Attachment D

PLAN - EQUIPMENT LAYOUT
 SHOWN AS CHANNELS 1 & 2:
 MIRROR IMAGE FOR CHANNELS 3 & 4

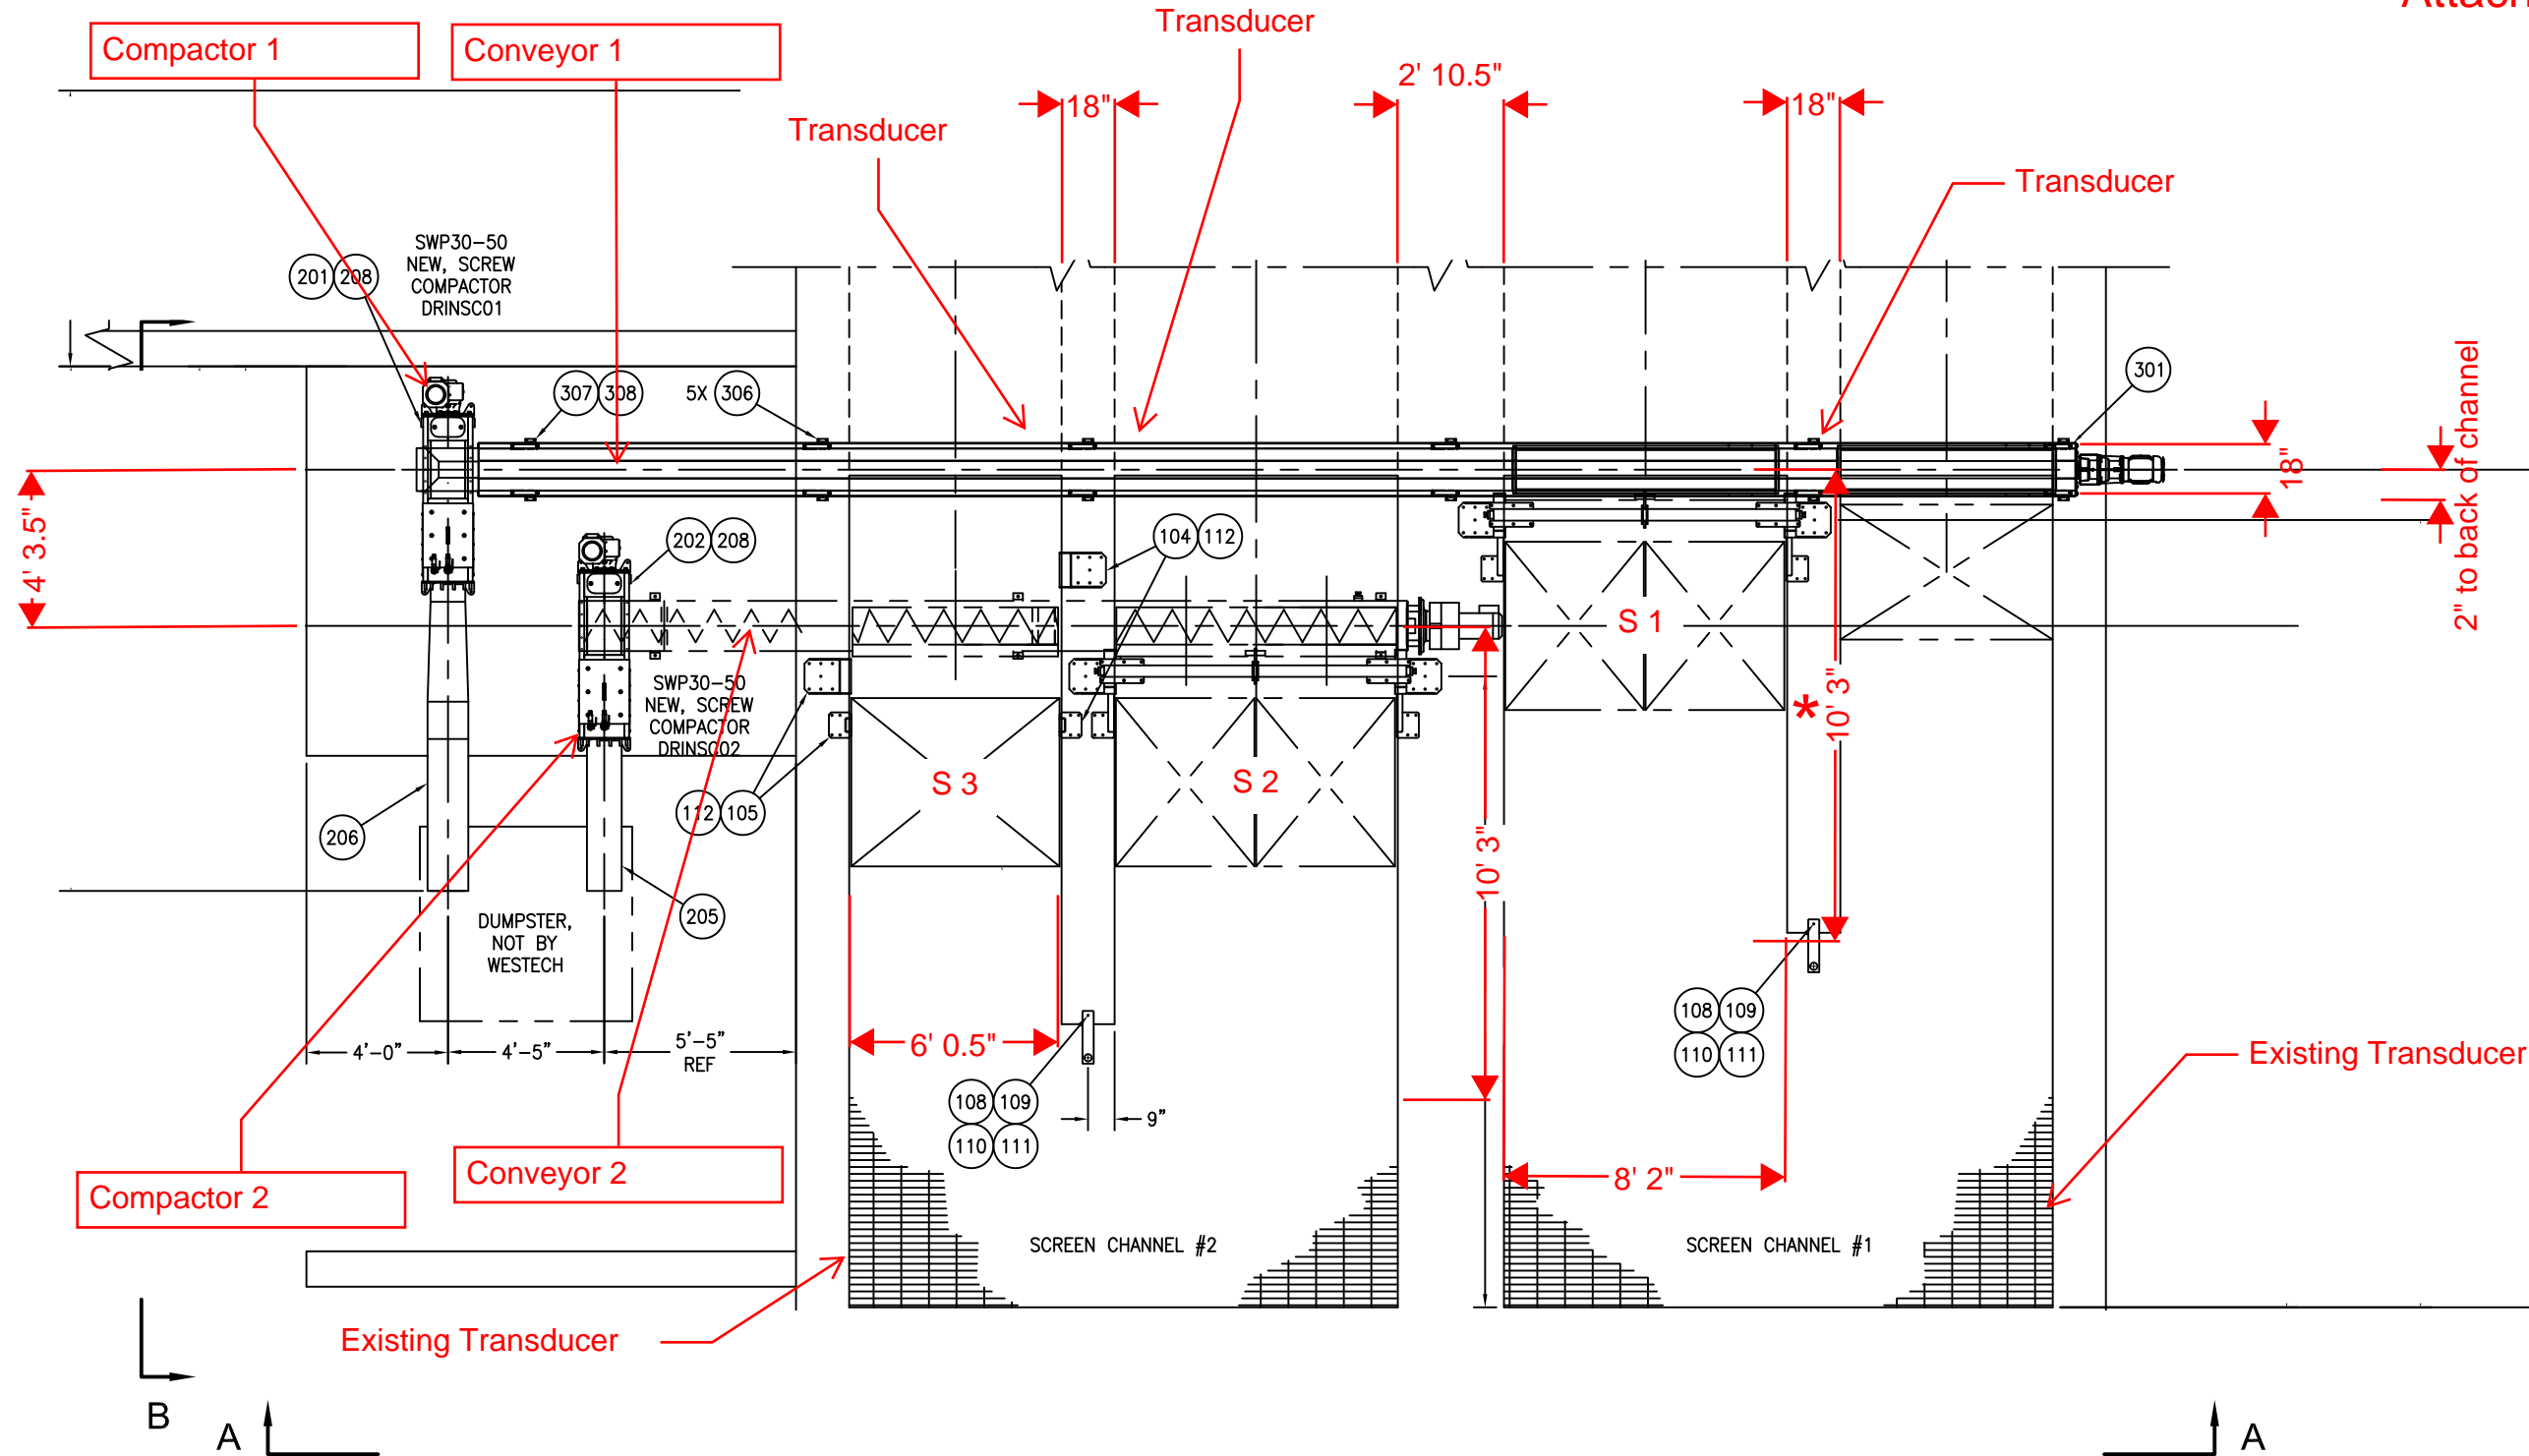
Motors must be on the right side of screen (when viewed from influent side) of new screen 4.

Motors must be on the left side of screen (when viewed from influent side) of new screen 3.

South Side
(Mirror for North Side)

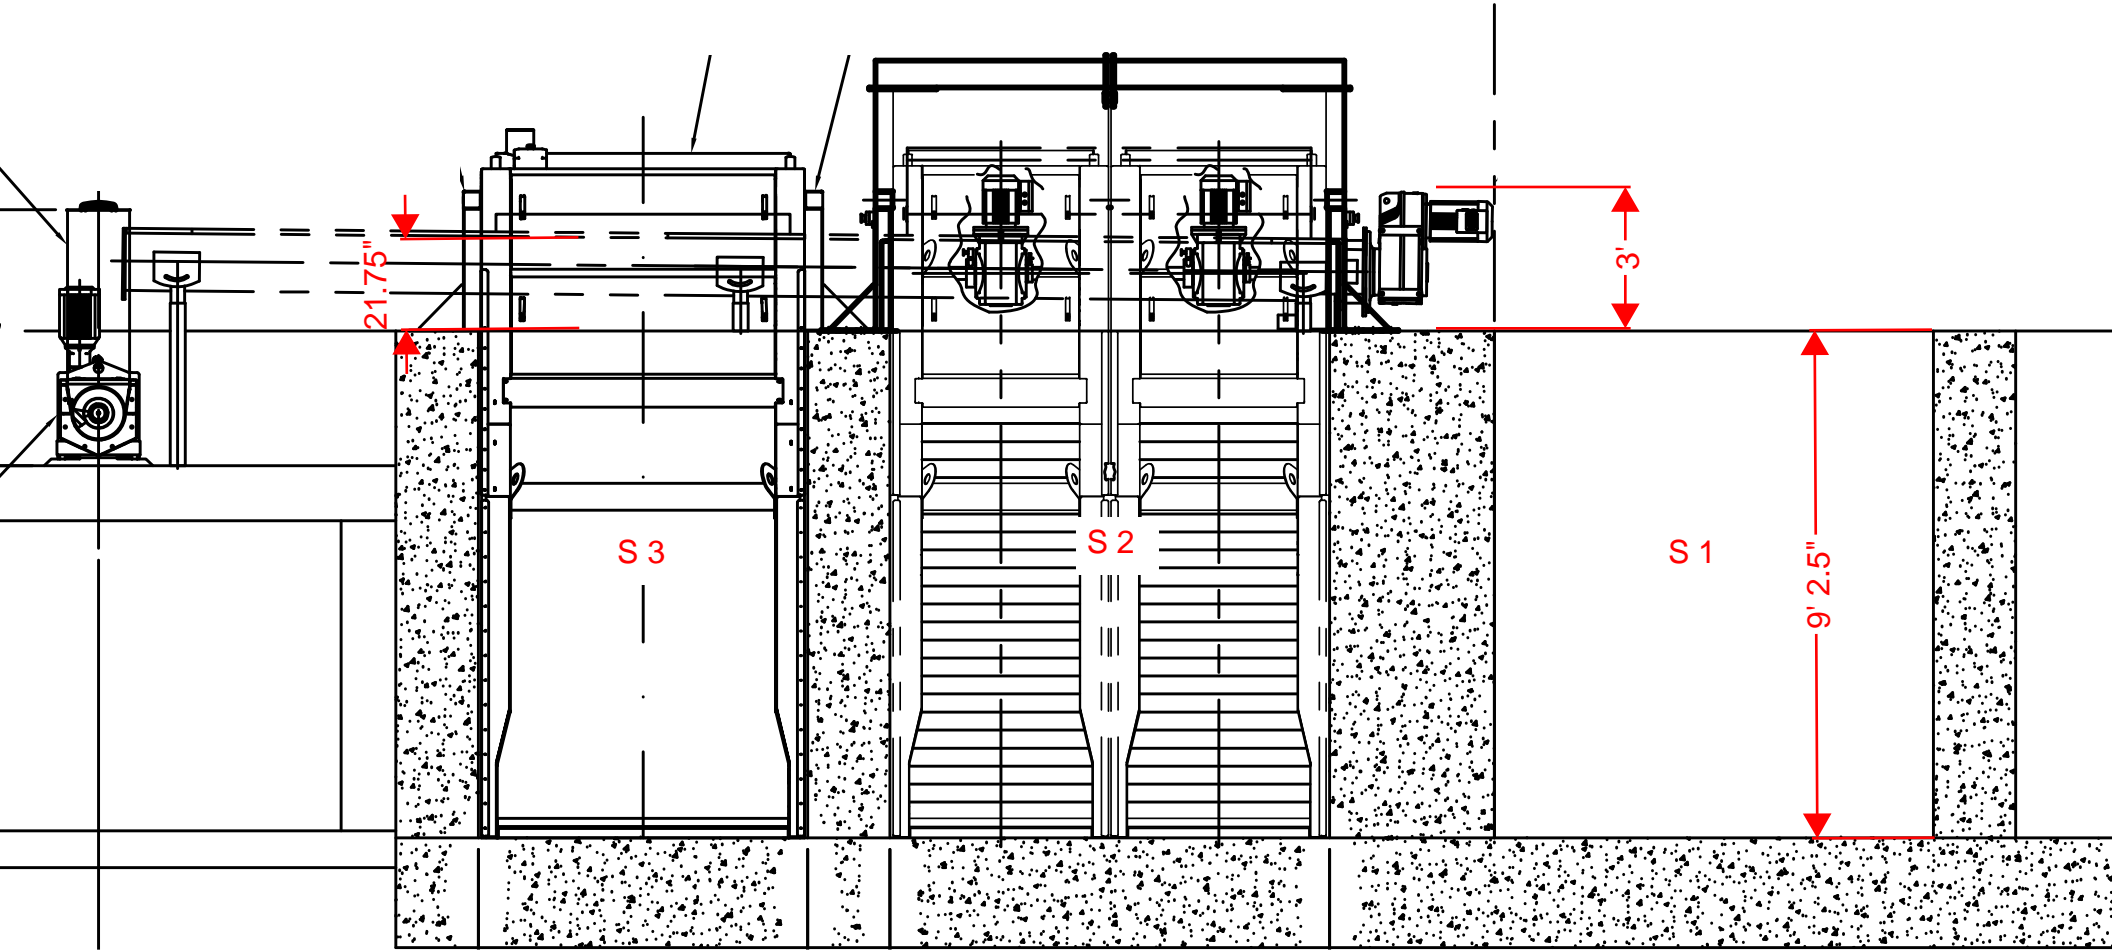
Channel depth may vary
by (but not limited to) half
an inch.
